Rezoning Application: PD 23-0783
Zoning Hearing Master Date: February 20, 2024
BOCC Land Use Meeting Date: April 9, 2024

Applicant: William L. Williams Jr.
Trustees Et Al

AGENCY REVIEW COMMENT SHEET

RE: Design Exception for Substandard Roadway (Riverview Drive) – RZ 23-0783 FOLIO # 075687-0000

TYPICAL SECTION
N.T.S.

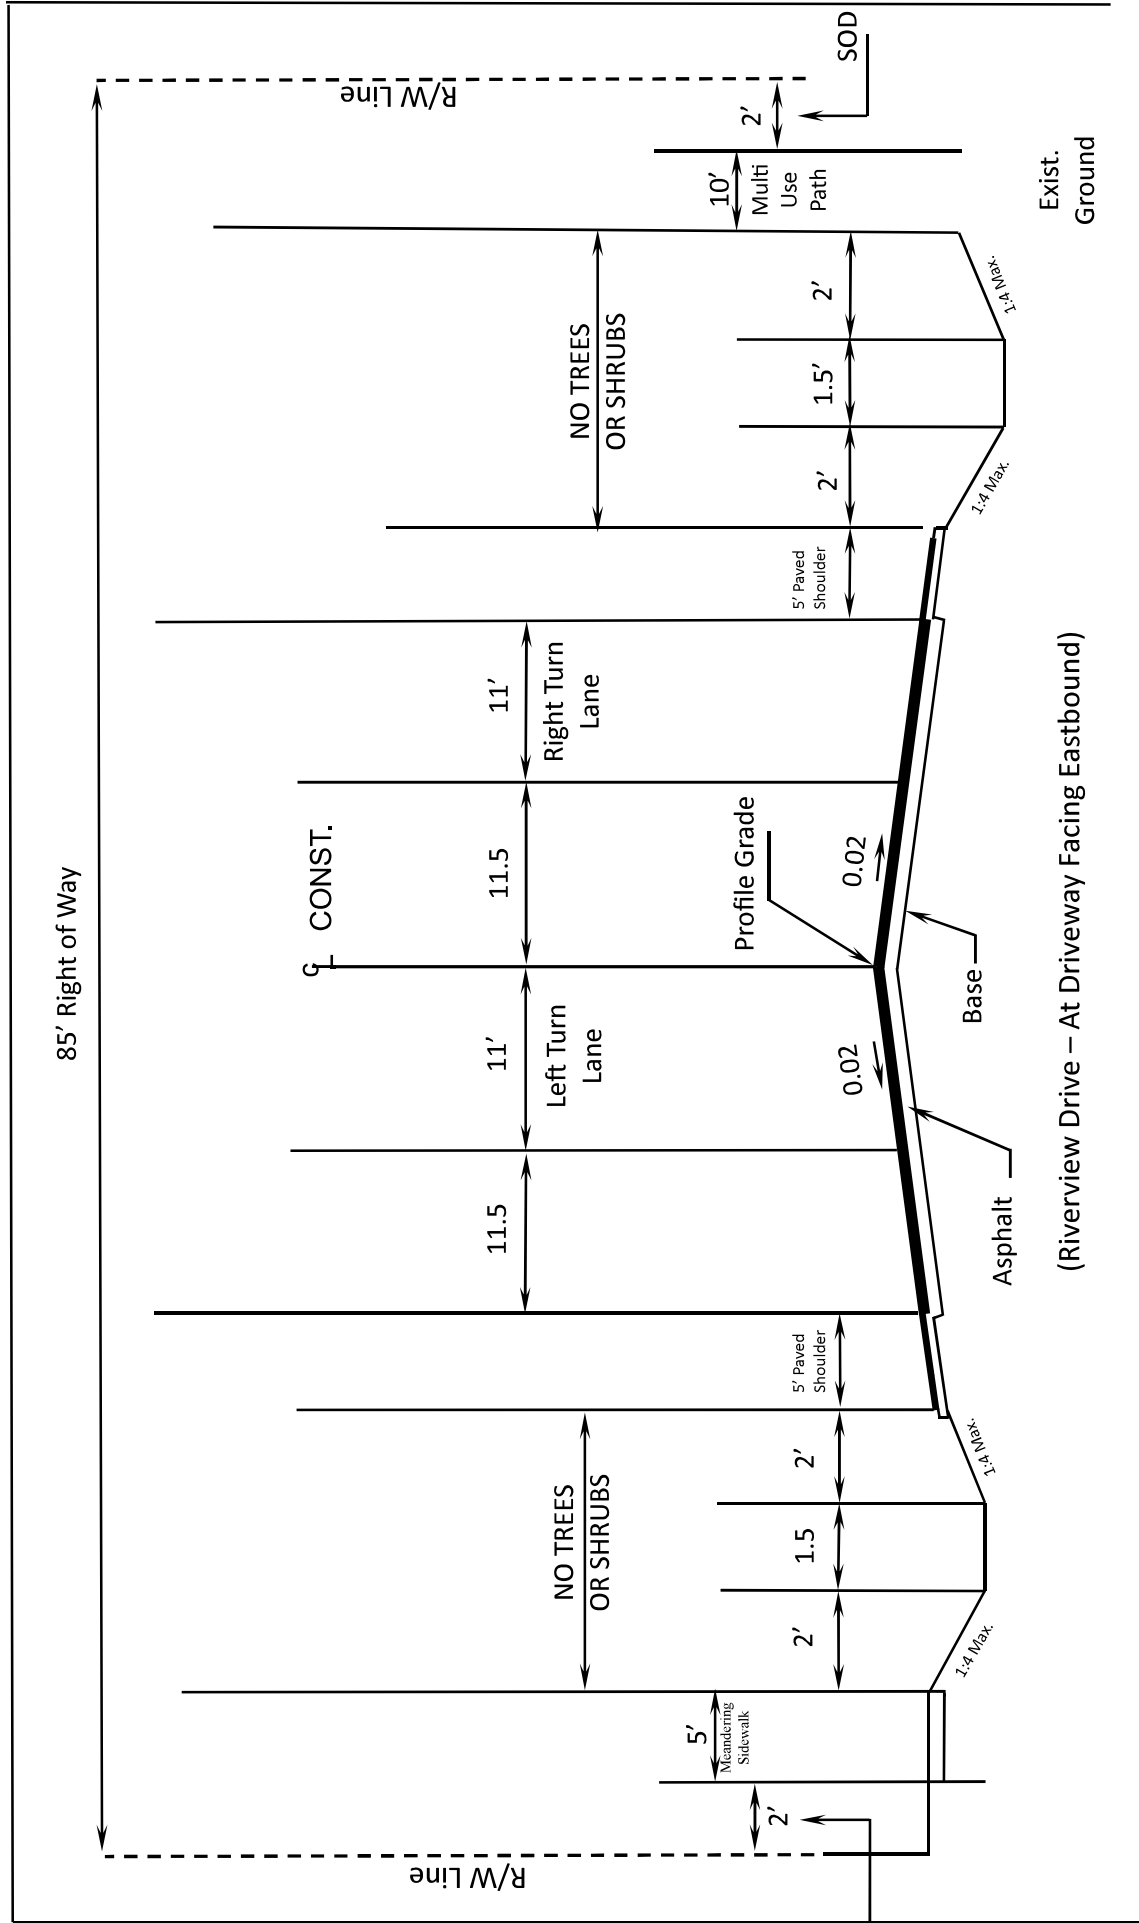
PROPOSED IMPROVEMENTS – In lieu of the 5 foot sidewalks that are required to be constructed along the project's frontage on Riverview Drive as part of the development of the site, the developer shall construct a 10 foot wide multi-use path along his frontage, a distance of approximately 1,508 feet. The developer will dedicate 10 feet of right-of-way along his project frontage, such that the total right-of-way width will be 85 feet.

JUSTIFICATION FOR THE REQUEST – The 10-foot wide multi-use path is being constructed in lieu of paved shoulders or bike lanes. Five (5) foot paved shoulders are being added in adherence with the TS-7 standard, which represents a safety upgrade relative to the existing condition. A TS-7 roadway also includes 12 foot travel lanes, and the travel lanes on the subject roadway are 11-1/2 feet wide. However, the 2023 Florida Greenbook, Table 3-2, Minimum Lane Widths, allows for collector roadways (Note that Riverview Drive is a collector roadway per the Hillsborough County Functional Classification Map.) to include 11 foot lane widths, as long as the design speed is 50 mph or less. The posted speed on this segment of Riverview Drive is 35 mph, and thus, the current lane width of 11-1/2 feet is acceptable.

Based upon the information provided by the application, this request is:

Approved

DRAWING NO. **TS-7**
SHEET NO. 1 OF 1

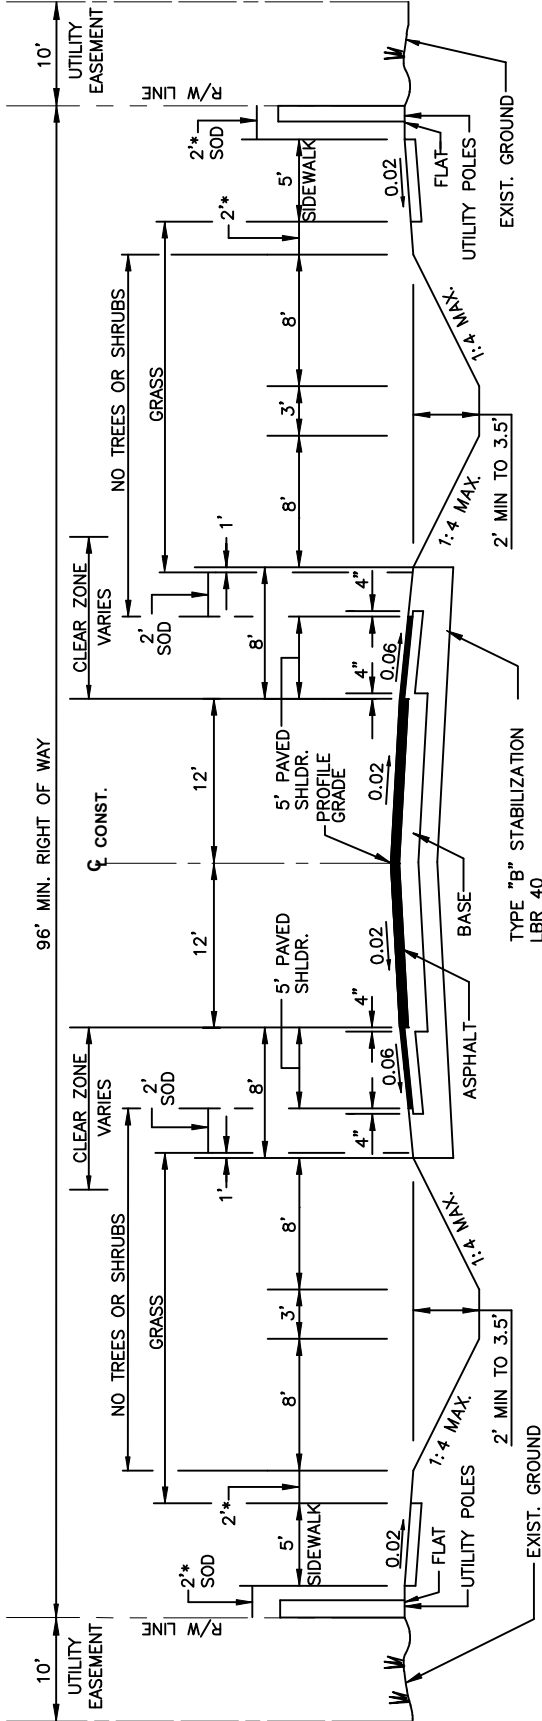
Pursuant to the Hillsborough County Transportation Technical Manual (TTM), the TS-7, rural collector roadway typical section requires 12-foot travel lanes, paved shoulders and sidewalks with open swales within a 96-foot wide right of way. The applicant is requesting a design exception to construct a roadway section along the project frontage that includes:

- 11.5-foot through lanes,
- 11-foot eastbound right turn lane,
- 11-foot westbound left turn lane,
- 5-foot paved shoulders,
- 10-foot multi-use path, and
- 10-foot dedicated right-of-way where necessary to accommodate the proposed section.
